VENTURE ON VENETUCCI

SITE DEVELOPMENT PLAN

COVER SHEET

V1_Site Development Plan.pdf Markup Summary

SITE DEVELOPMENT PLAN

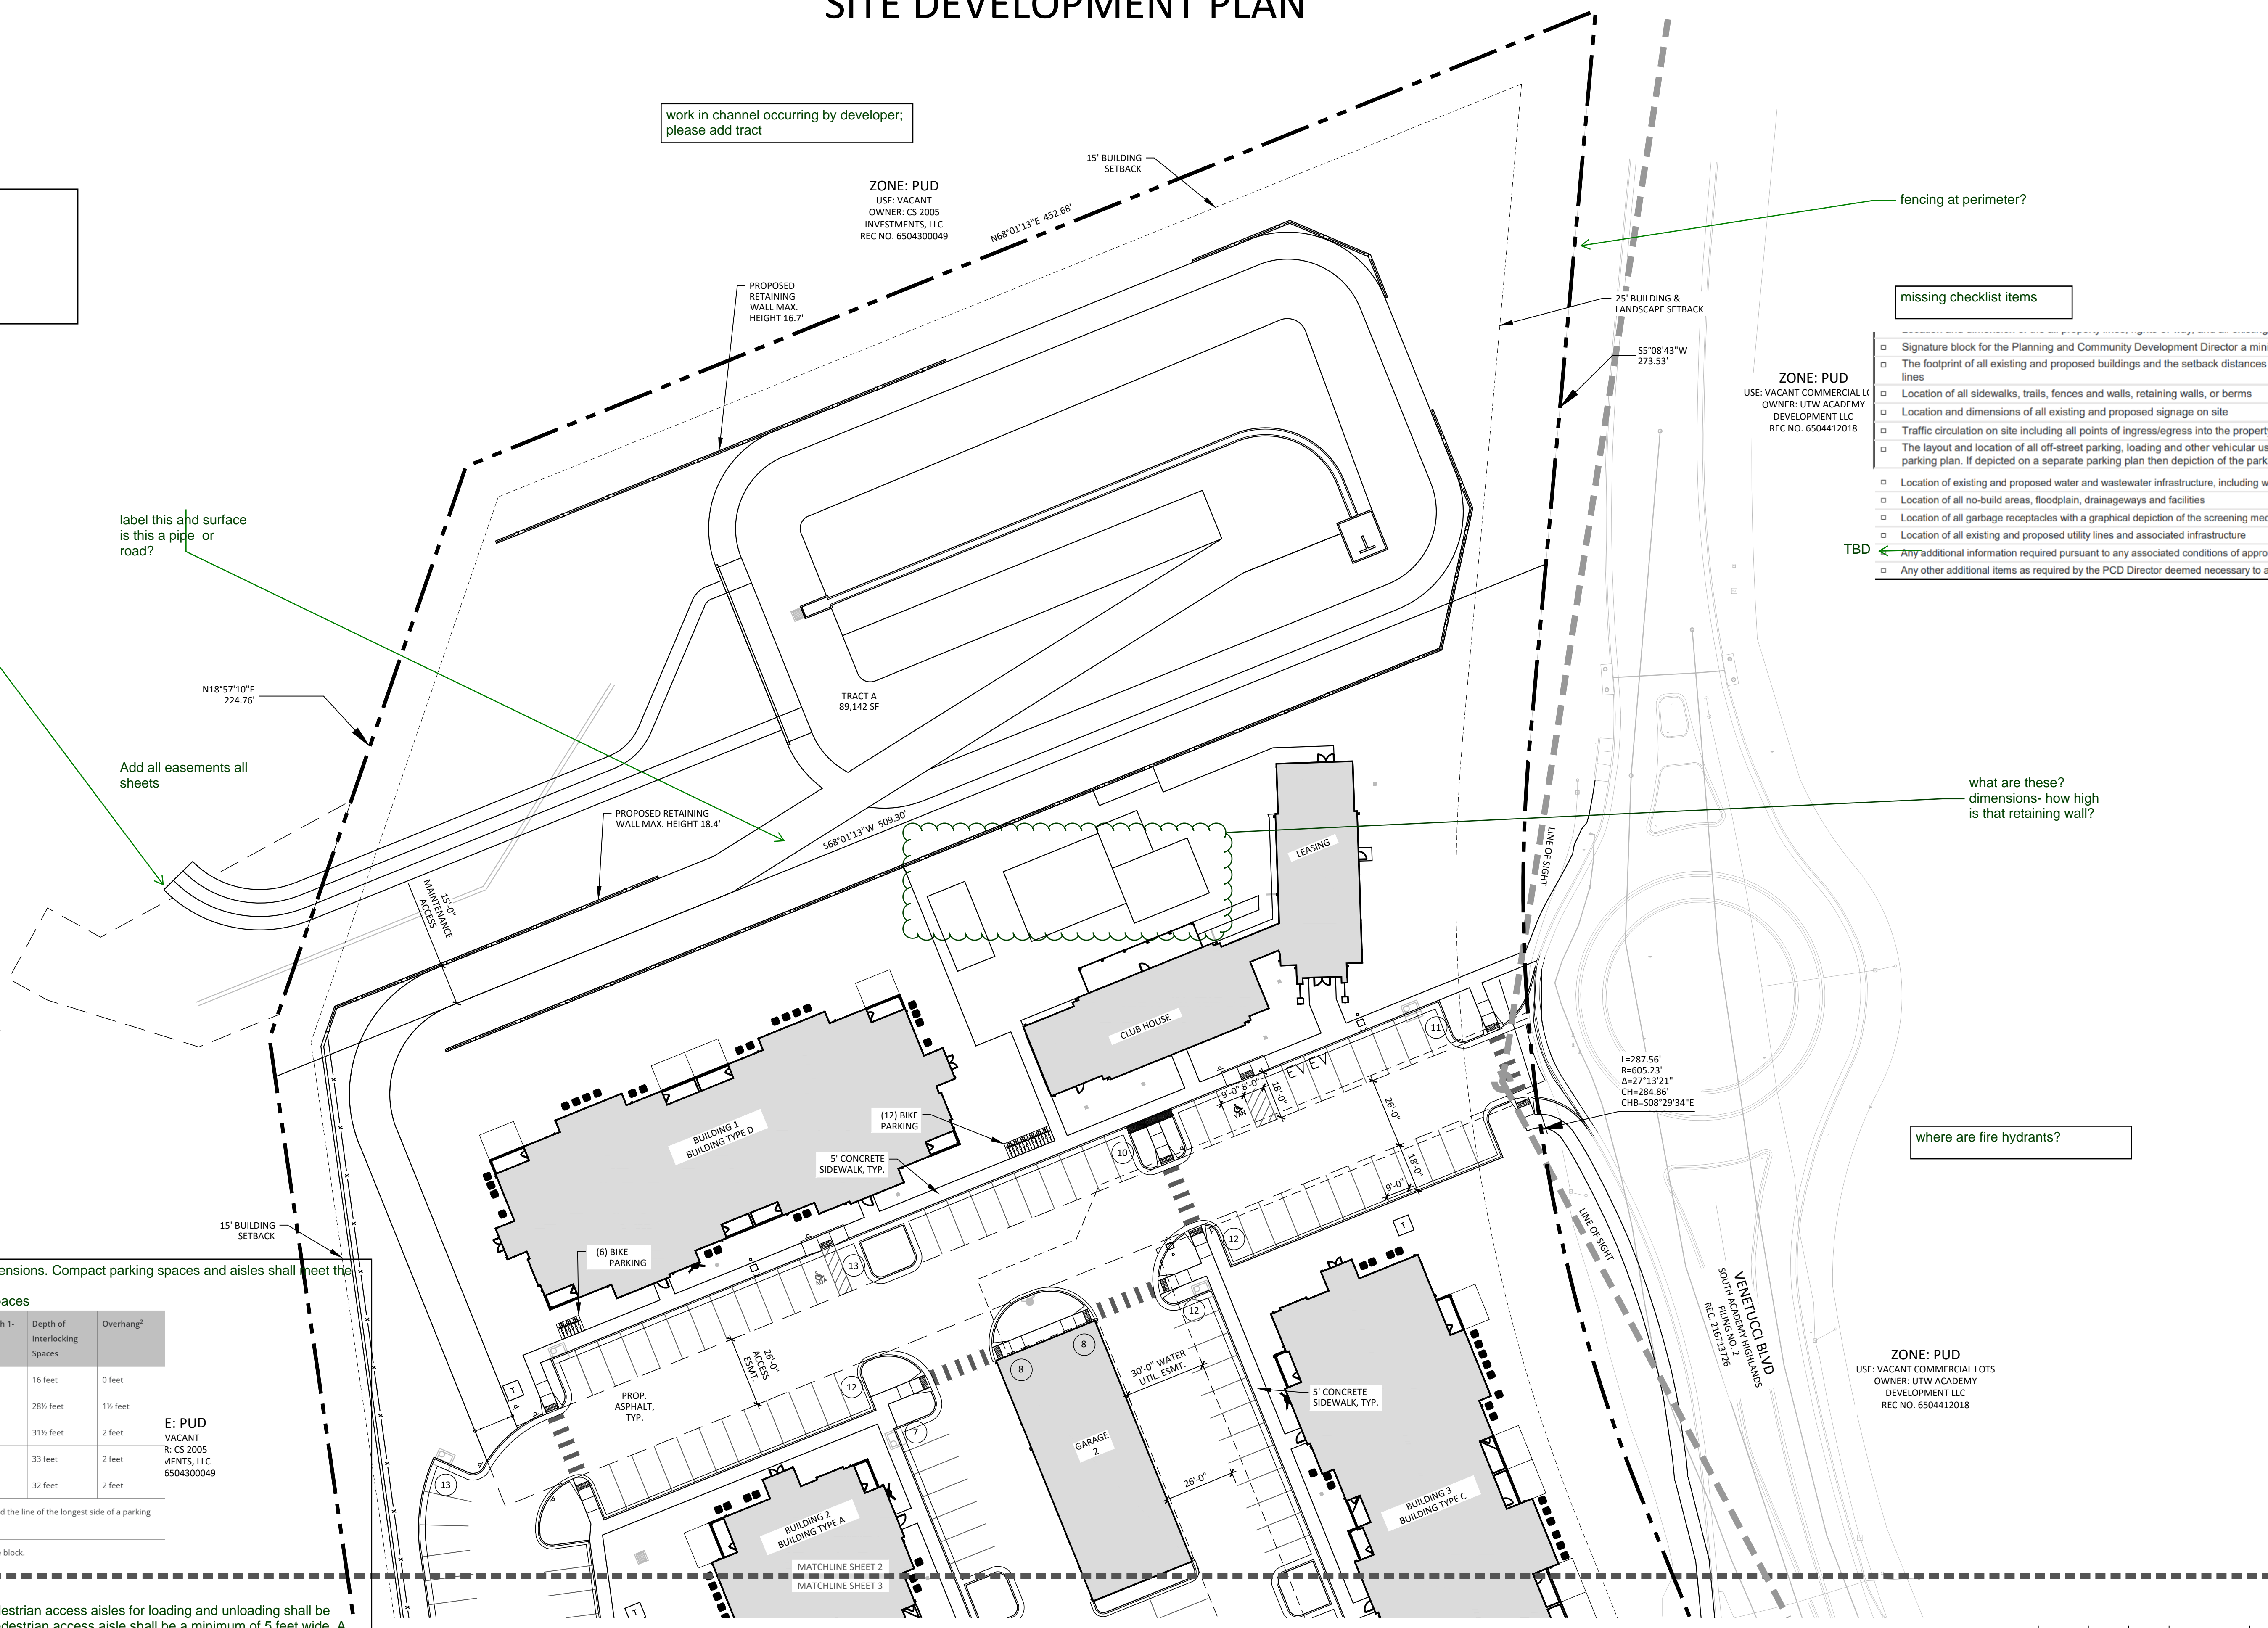
work in channel occurring by developer;
please add tract

does this outfall to channel?
show tract

label this and surface
is this a pipe or road?

Add all easements all sheets

what are these?
dimensions- how high
is that retaining wall?

where are fire hydrants?

Please consider substituting compact spaces from some of the regular spaces to increase parking. Please contact City of Fountain for the limitations regarding off street parking on Venetucci.

SITE DEVELOPMENT PLAN

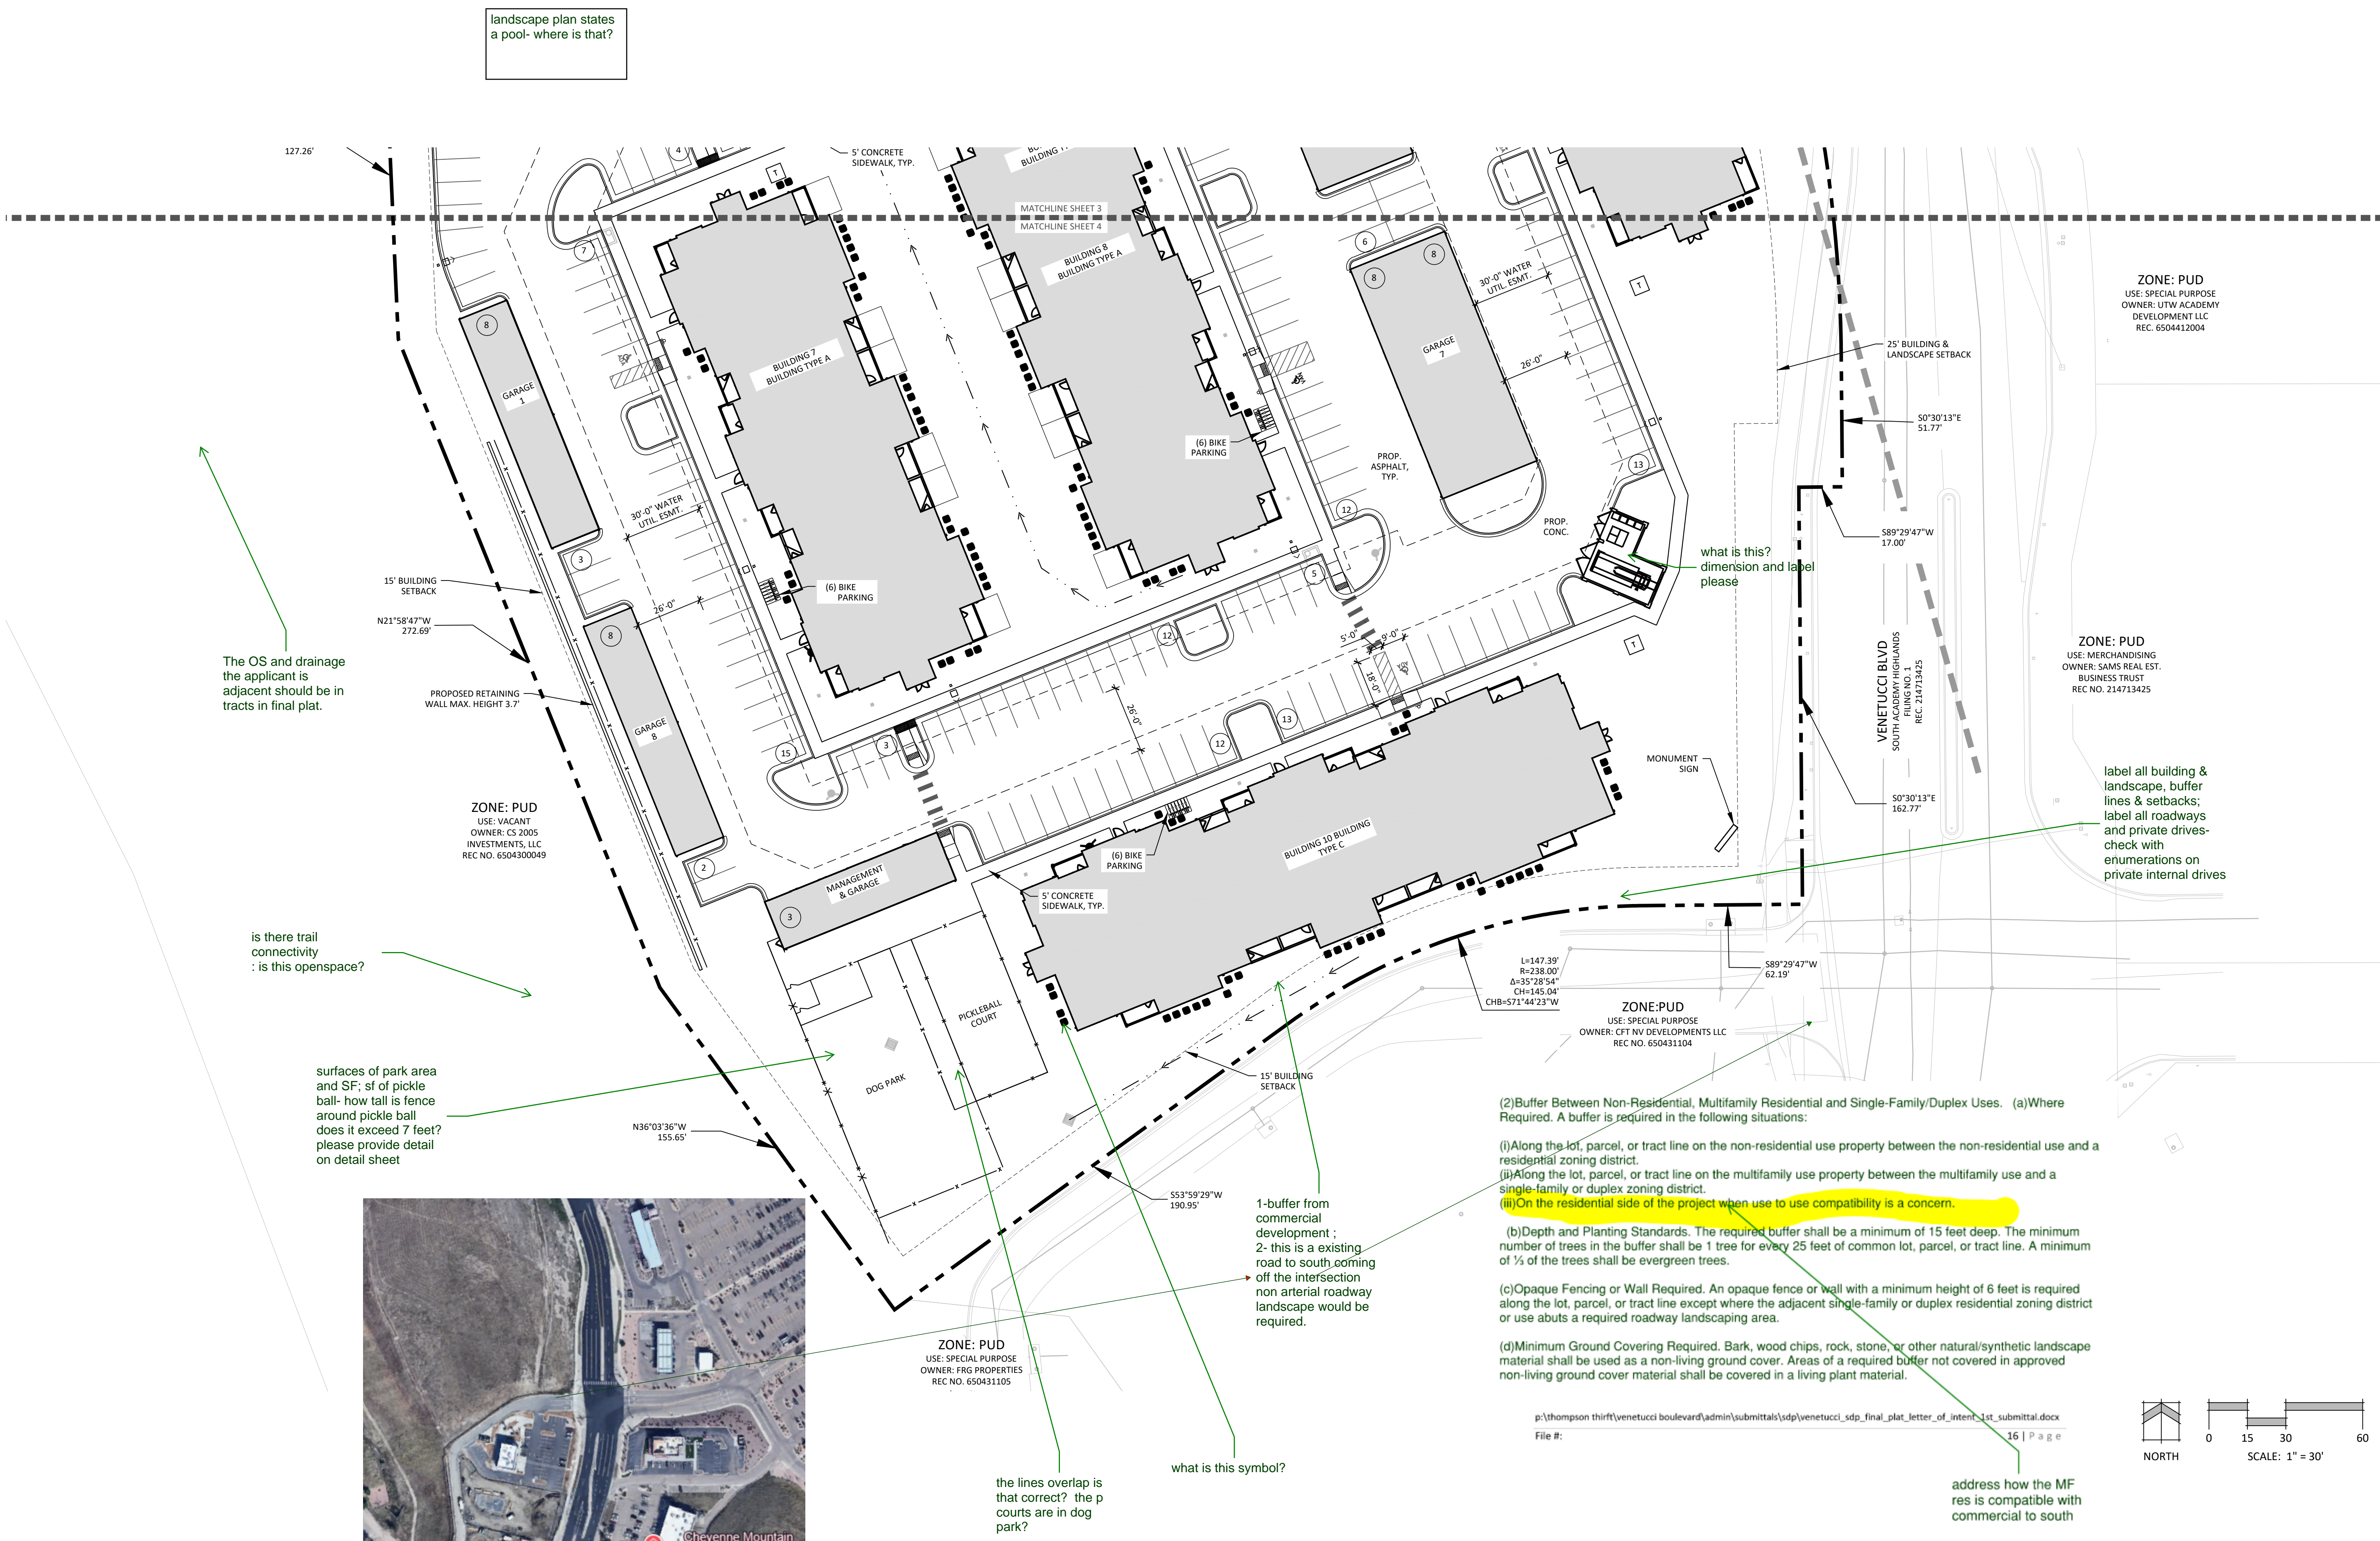
1- buffer from commercial development ;
 2- this is a existing road to south coming off the intersection non arterial roadway landscape would be required.

label all building & landscape, buffer lines & setbacks; label all roadways and private drives- check with enumerations on private internal drives

The OS and drainage the applicant is adjacent should be in tracts in final plat.

is there trail connectivity
: is this openspace?

what is this symbol?

the lines overlap is that correct? the p courts are in dog park?

what is this? dimension and label please

surfaces of park area and SF; sf of pickle ball- how tall is fence around pickle ball does it exceed 7 feet? please provide detail on detail sheet

landscape plan states a pool- where is that?

PARKING STALL LAYOUT DETAILS

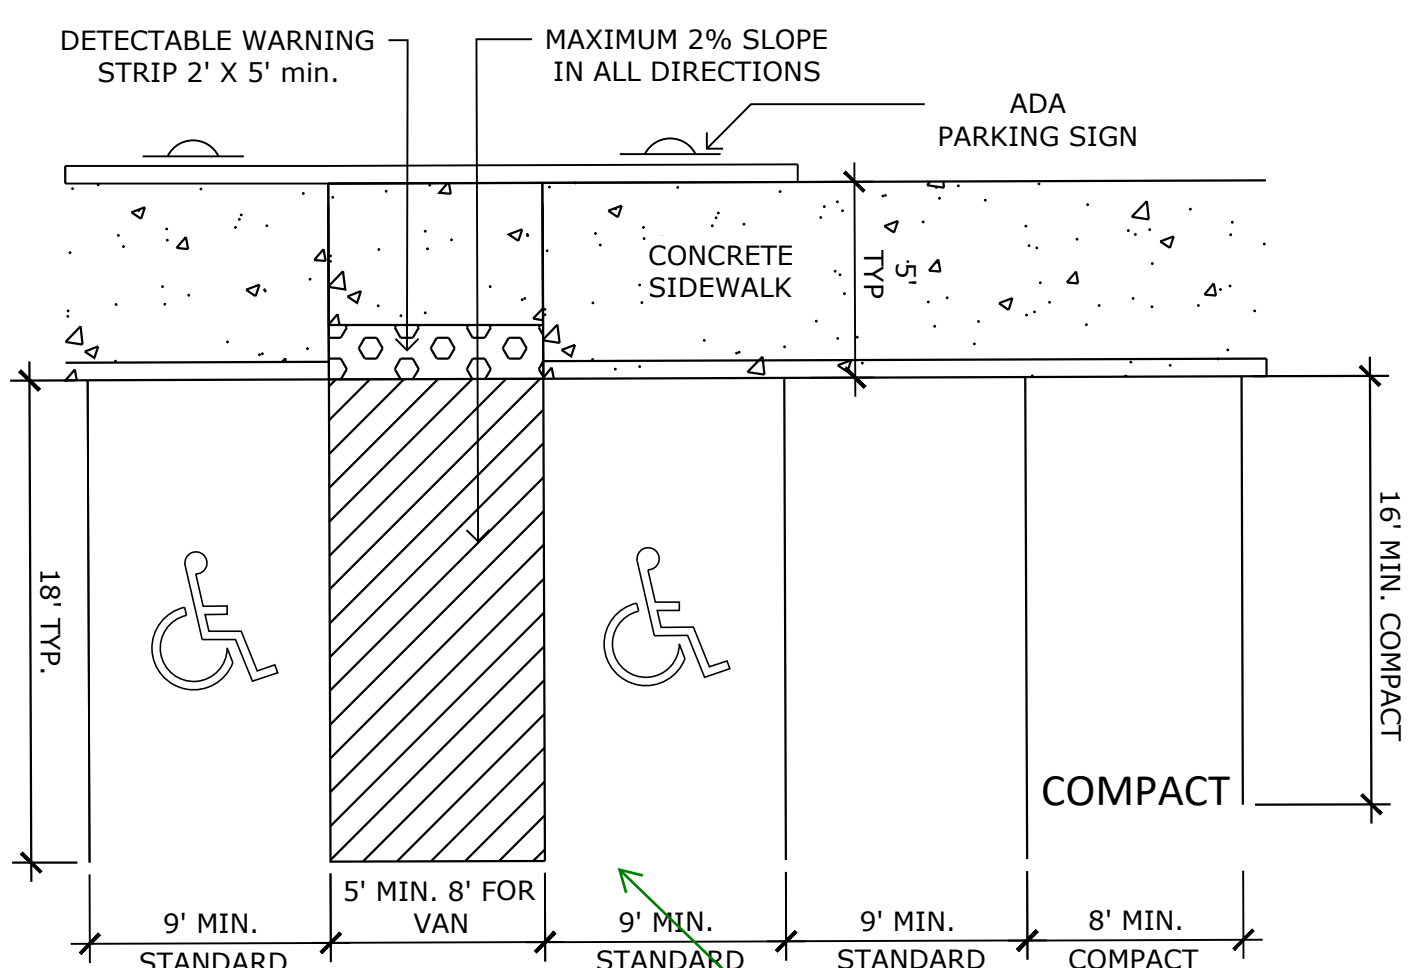
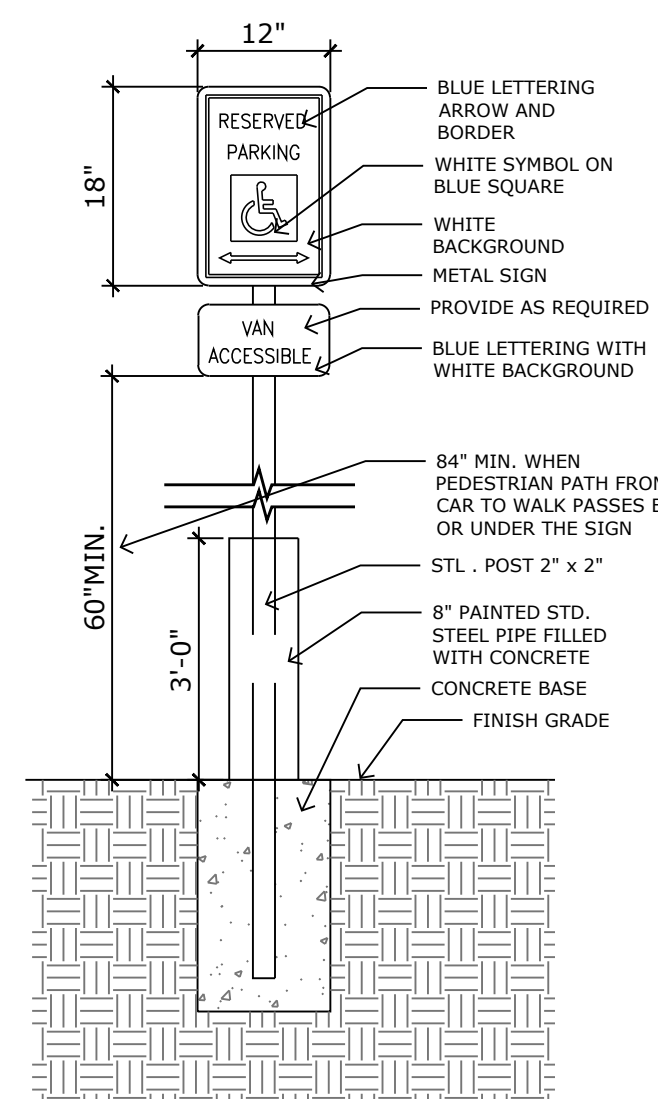
it appears some of the symbols are located on only one side of the ramp in the drawing set

1 GUARDRAIL
NTS

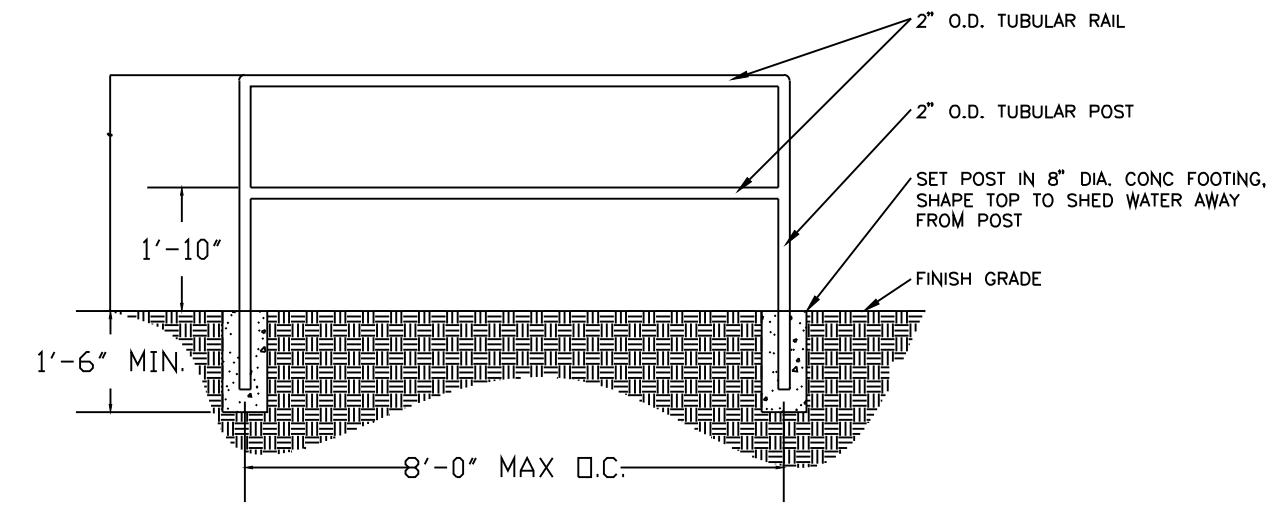
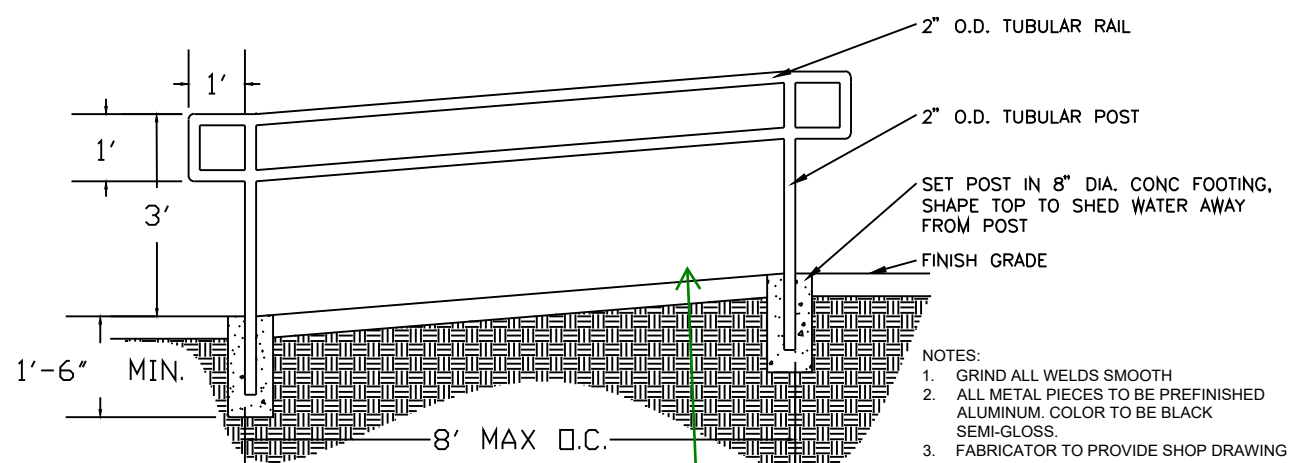
where are these on planset?

retaining wall detail please
